Southwark Cyclists QW 83 Excursion (19.5.17)

Q83 - Route Overview

Section 1

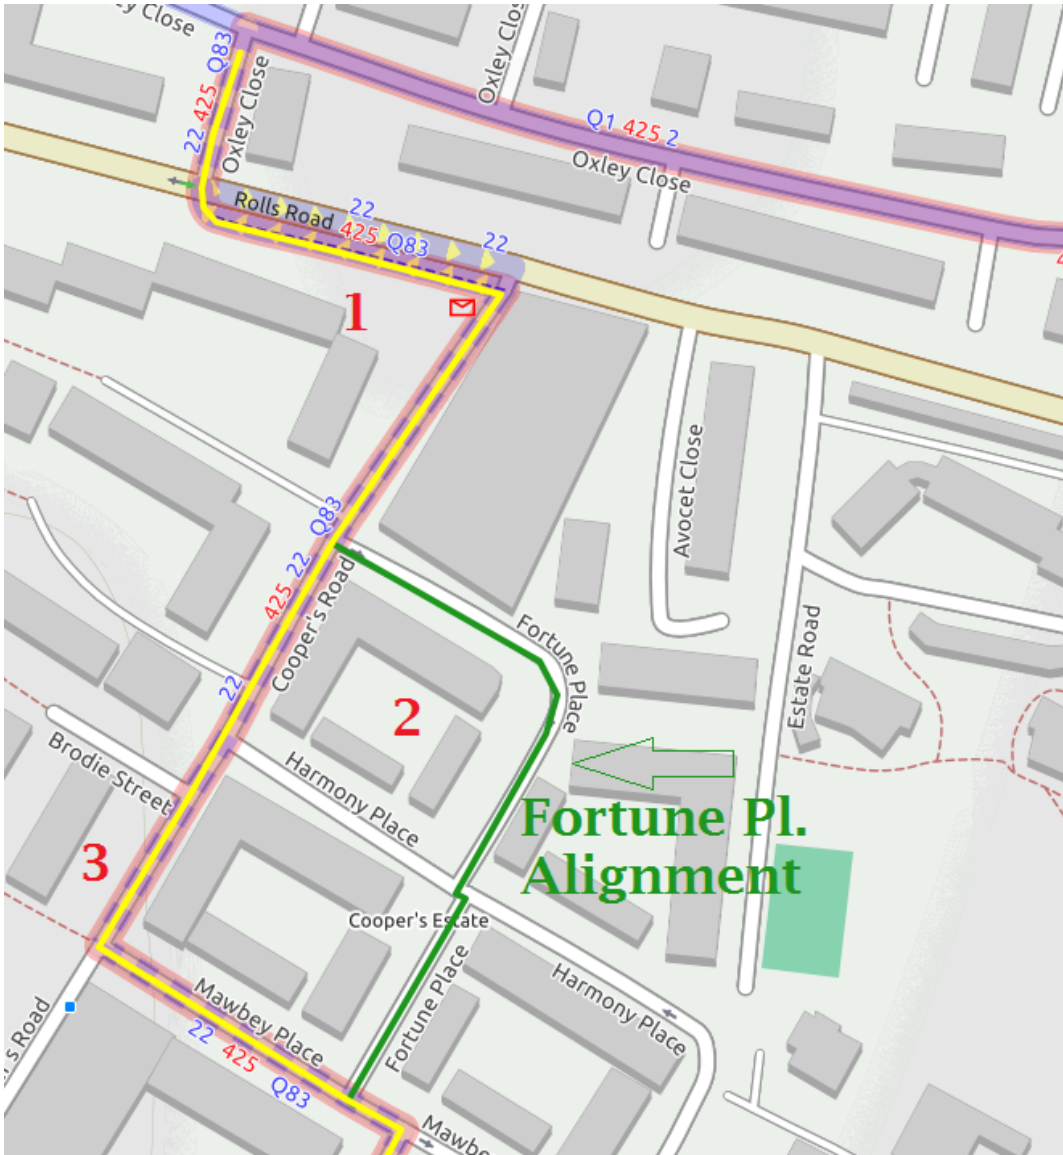
1 - Cyclists to use current shared pavement area with re-aligned 'mouth' heading to and from Oxley Close (other plans were to remove parking, on the south side (pictured), in favour of light segregation; however Southwark have deemed only some parking can be removed, so not enough for this option)

Dual Provision: currently not many use this shared path; will these changes lead to more doing so? Or will there still be a two-tier cycling provision here?

Issue arising: coming from Rolls Rd. and turning into Cooper's Rd. (from shared use cycle path) cyclists are in an unnatural position for drivers coming from Cooper's Rd. (pictured below) and are obscured by parked cars on Cooper's rd. - likewise drivers turning left into Cooper's (from Rolls rd.) may not expect a cyclists (essentially) to be crossing half of the road and turning right.

Another issue: Traffic on Rolls Rd. seems to move very fast and the current raised table (Oxley cl. to Rolls rd.) does little to deter such speed - we need to know nature of this traffic to assess what can be done (speed / volume).

Solution: currently Cooper's Rd. (a residential street) is used as a shortcut from the A2. onto Rolls Rd., filtering this shortcut would make this turn a lot less hazardous (given the alternatives available). The removal of parking from the approach of Cooper's Rd onto Rolls Rd. is also an option to improve sight lines.

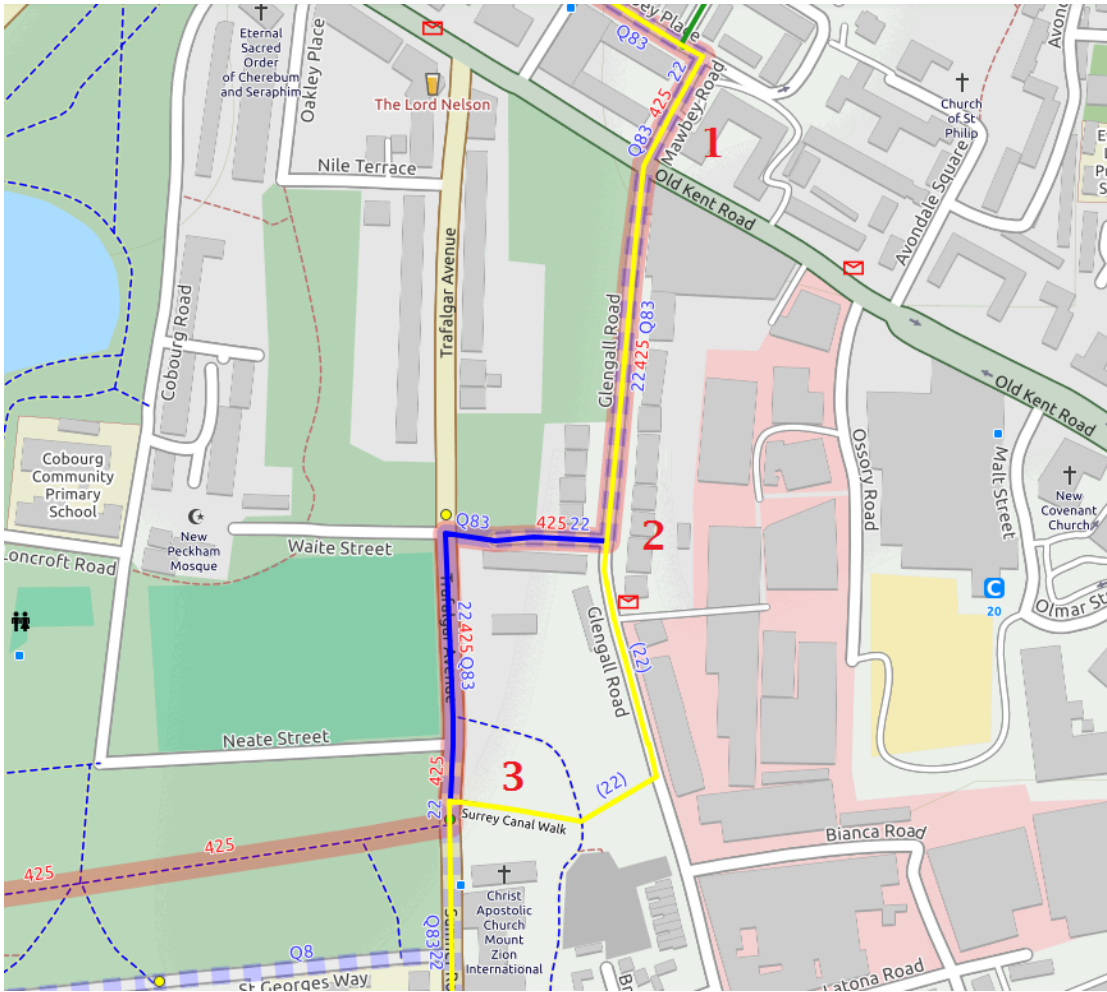
2 & 3 - Cyclists are to go down Cooper's rd. and turn right onto Mawbey Pl..

Issues and suggestions arising: Cooper's rd. is patently too busy and too narrow so a suggestion was made to send the cycleway through Fortune Pl. (seen above in green and pictured below), so cutting out some of the unpleasantries. One of our attendees did a test ride and said it was a good route. But whose land is this? We are not sure as it may be private, which may lead to complications.

This alignment would also negate some of the blind corners and possible head-on collisions one has when turning in and out of Mawbey pl. and Cooper's rd - this partially caused vehicles parked on the single yellow lines or on corners - these lines should be made double yellow in any case.

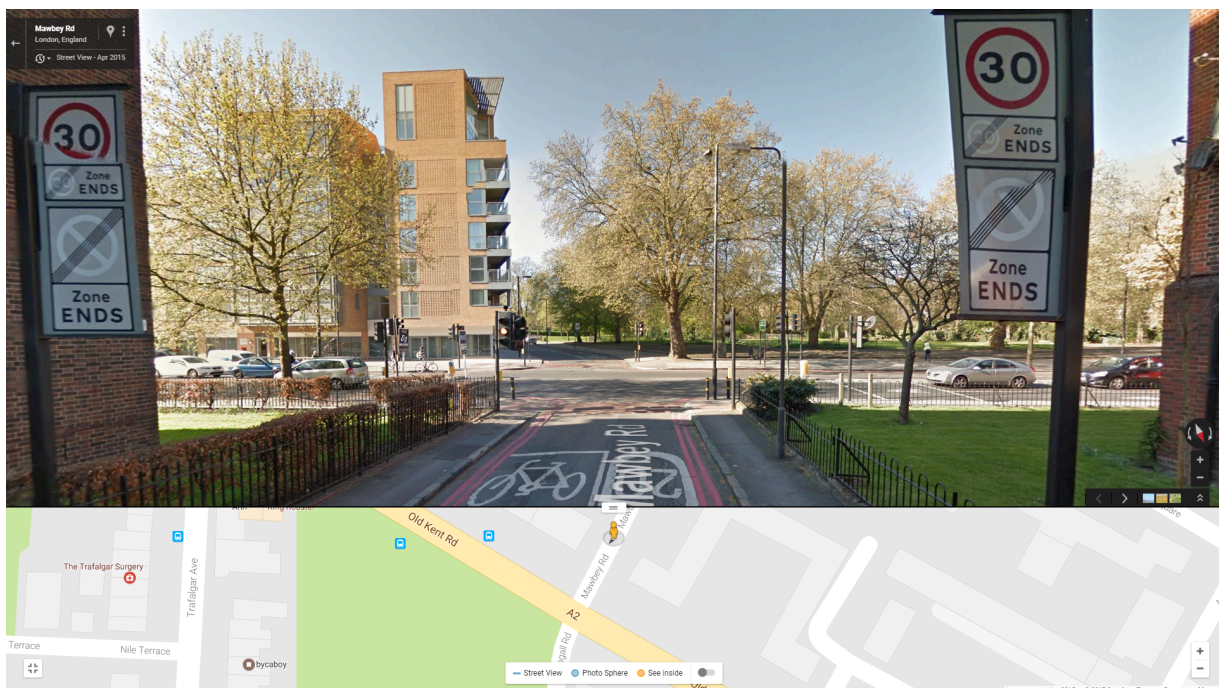
1 - Mawbey Rd. is to be filtered (pictured below) at the jct. with the New Kent Road (A2) - so a lot of the traffic we experienced down there will be there no longer. This consultation went through last year (TFL), so I am not sure if it actually classes as being part of the Quietway design or not (though it shall use it). Going north, we understand cyclists will at least get an early release, if not separation from left and right turning traffic

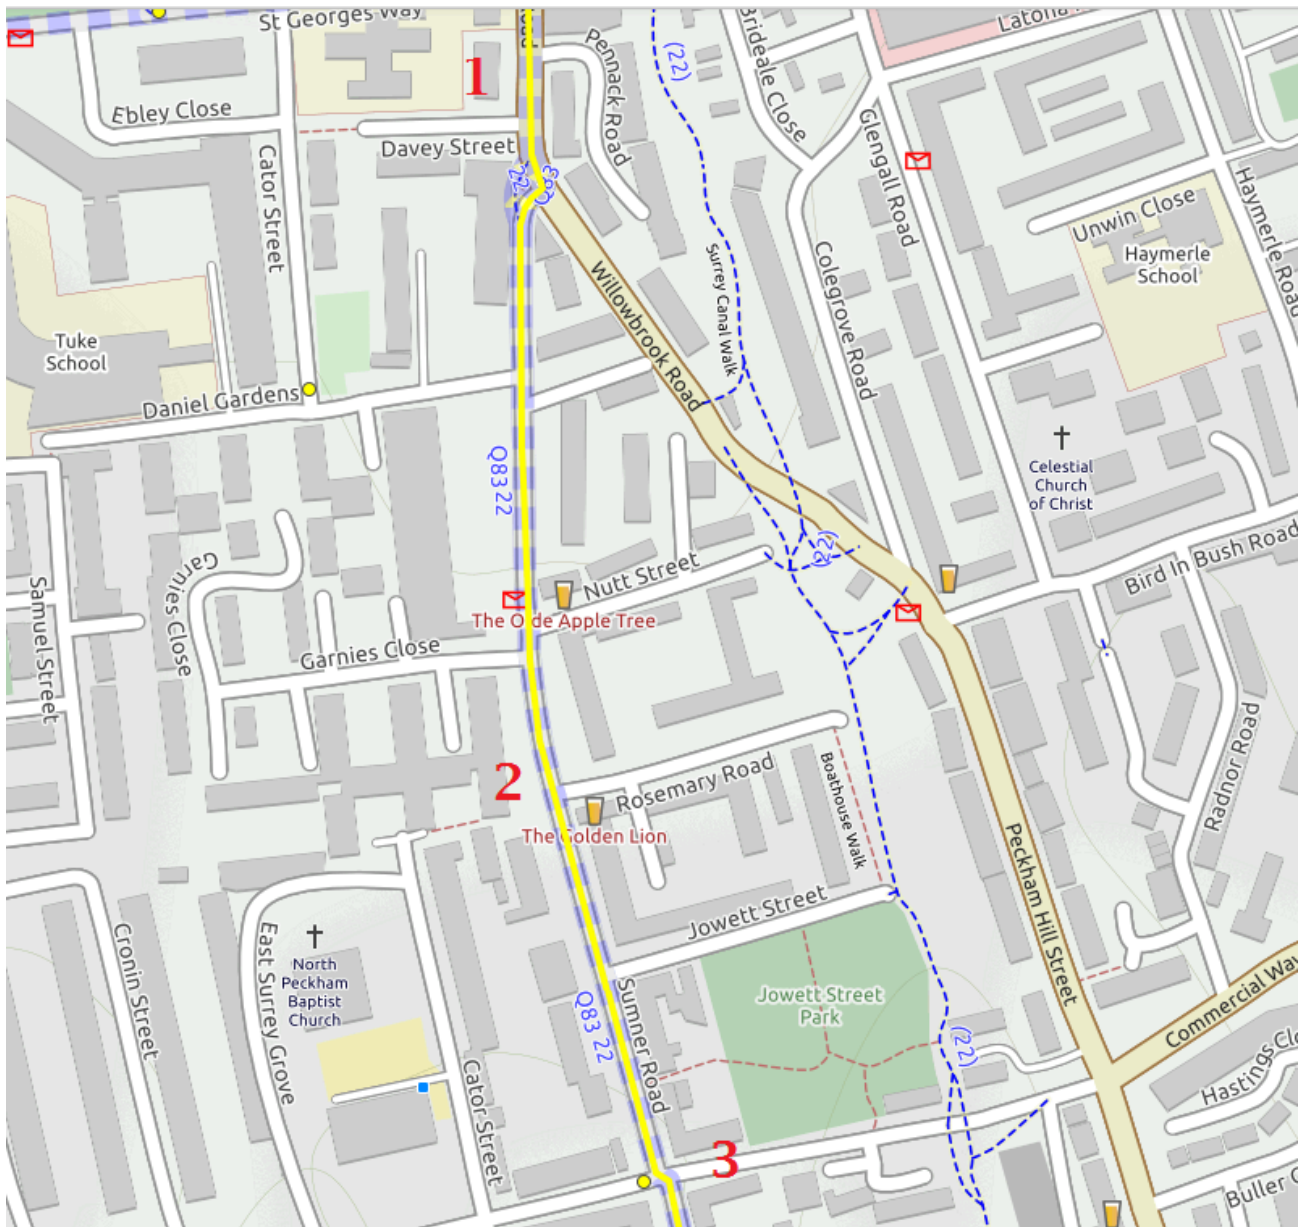
3 - According to the current alignment the awkward gate will be changed and a larger bell-mouth will be installed (see below) - along with an easier arrangement for the pedestrian/ cycle crossing. Even if the alignment changed to Glengall Terrace we are hopeful that this work would take place and an easier crossing to Burgess Park would be installed, as the cycleway will mean work must be done on the toucan crossing. The two way cycle track would be on the right of this photo.

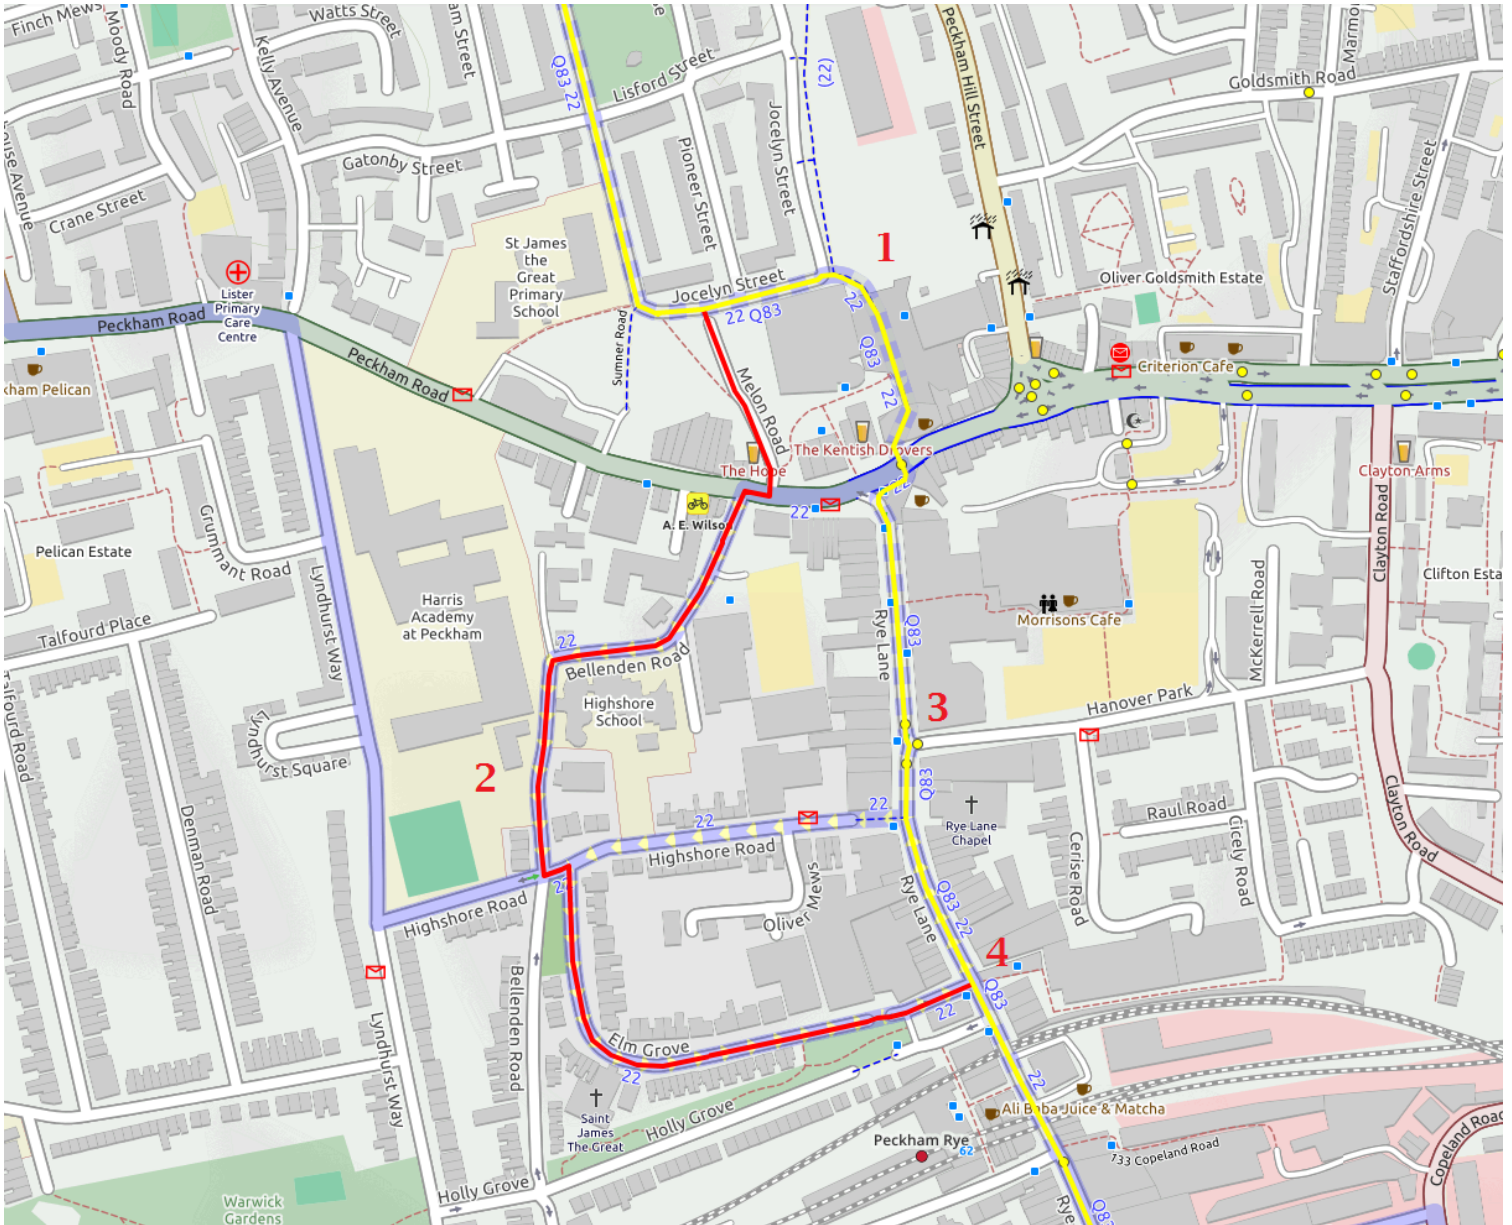
3 - the offset junction of Sumner and Commercial Way - currently no proposals. A very busy crossroads to traverse as traffic rushes down Commercial Way and Sumner loses priority. Not suitable for a Quietway.

A recommendation: filter Sumner rd. at this point and signalise the junction just as Dunton rd. was signalised on Q1 - or Webb St./ Rothsay (see both below - it could even be a push-button signal/ proximity activated).

Another option: if filtering is not possible, installing a parallel crossing alongside the current zebra crossing which goes across Commercial Way at this junction. Perhaps cyclists could use a small shared space area to access the crossing. It could also be signalised to assist this process (though would pedestrians lose priority this way? - a button would be required to operate it). Below is an point on Q1 where a parallel crossing has been installed across two offset roads.

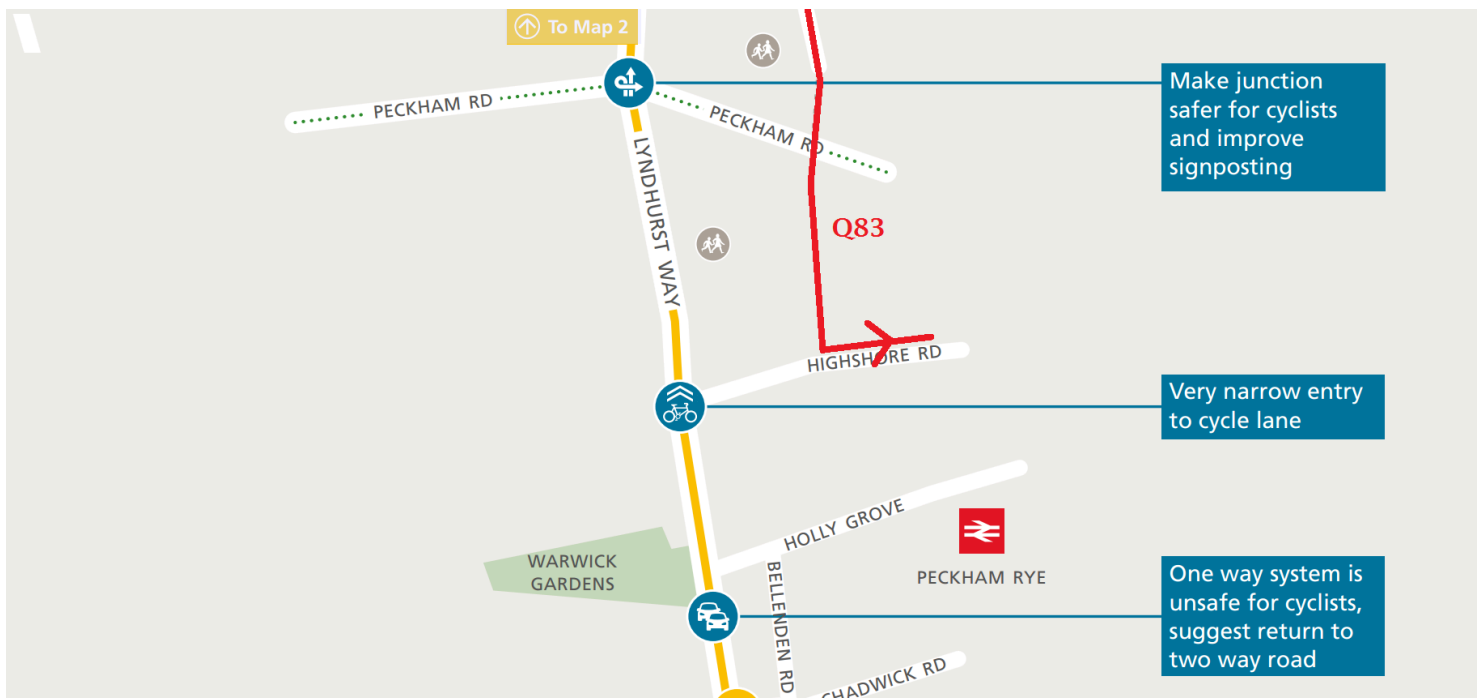
2 - Should Q83 actually go through the Library area at all?

Following the red alignment on the map, Southwark Cyclists want it to down Melon Rd. and then down Bellenden Rd and onto Rye Lane; however TFL have refused to fund a crossing there as:

Our response to this is that given Bellenden Rd. has an unsignalised crossing from Melon Rd, and is not cycle-friendly, how can you expect cyclists to use it, when Rye Lane is clearly the safer option at the moment? Yes Rye Lane may be desirable; however it is already manageable in its current form and the crossing from Melon Rd. to Bellenden *is not* - plus Rye Lane is easily accessed from multiple points along Bellenden Rd. Melon Rd. also offers a 24hr route, which the Canal Path does not. In terms of objection **A)** : our proposal is to amalgamate the current pedestrian crossing over the A202 with a parallel cycle crossing and not add another in.
